VAN-30-21.50

SUPERSTRUCTURE DETAILS

BRIDGE NO VAN-30-2219

US R 30 UNDER T.R. 197

FRAMING PLAN

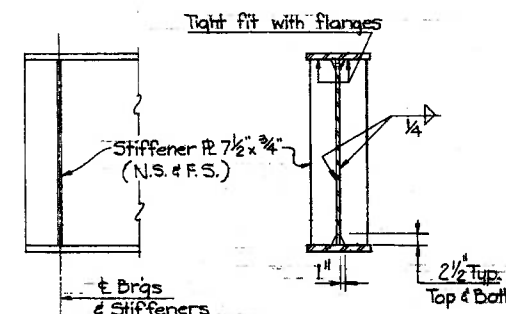
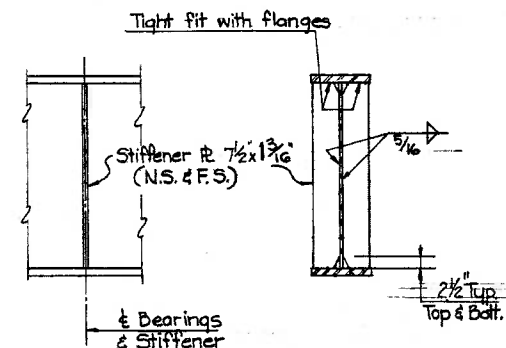
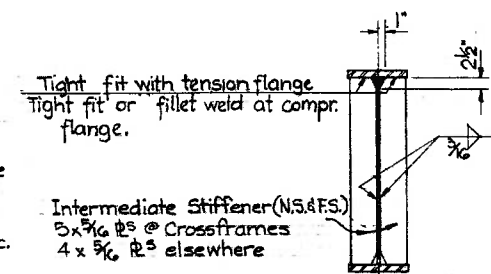
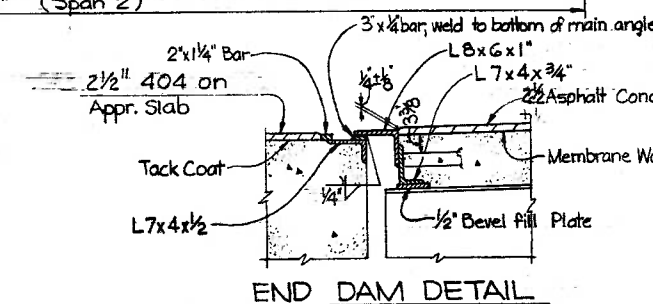
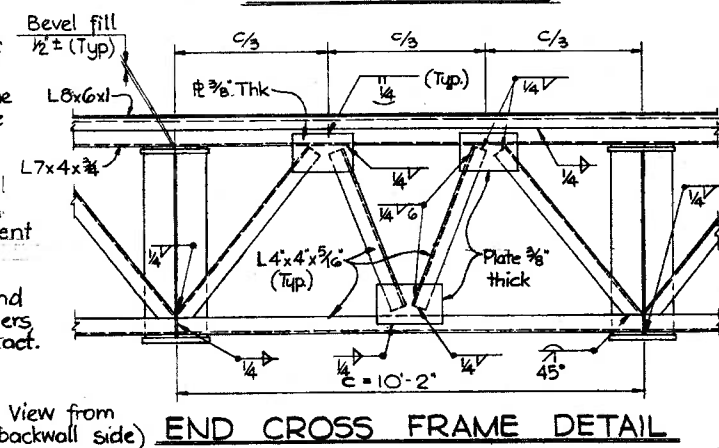
Proposed WC2 Repair

Proposed WC1 Repair

Pictures 414-418

West Beam Limits of Heat Straightening: 42' from South Abut. Wall Face to 52' from South Abut. Wall Face -VERIFY???

Cross Frame Replacements

Proposed WC1 Repair

Proposed WC2 Repair

Proposed WC1 Repair

East Beam Limits of Heat Straightening: 26' from South Abut. Wall Face to 68' from South Abut. Wall Face

West Beam 9 outside & 9 inside stiffeners bent

East Beam 10 outside & 10 inside stiffeners bent

X-frame location
